10-03 KROGER 025-387 - COLLIERVILLE, TN (WIW)

Issue Name : RTU1 Alarm Code
Description : RTU is displaying alarm 93, see picture attached.
Created By : National TAB **Assigned To :** National TAB - Will Turnbough
Status : Open
Originated Date : 10/05/2022 - Travis Halter - National TAB

Issue Name : RTU1 is not running

Issue Name : RTU1&2 Prodigy Alarms

FuseIT7d9089c1e61c47.jpeg

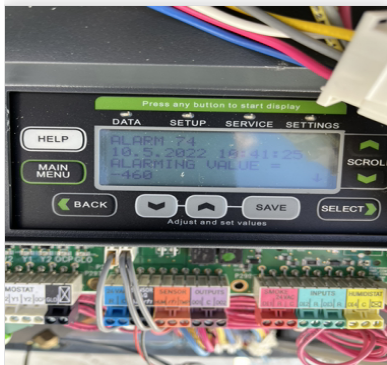
Description : Both units have alarm 74

- Code information message: "Equipment local zone temperature sensor failure A2. Failed or miswired zone temperature sensor causing a loss of local temperature sensor data monitored at P298-6 and 7 sensor is 11Kohm @ 77 degree type 2 sensor temperature range is 36 - 100 degrees F.
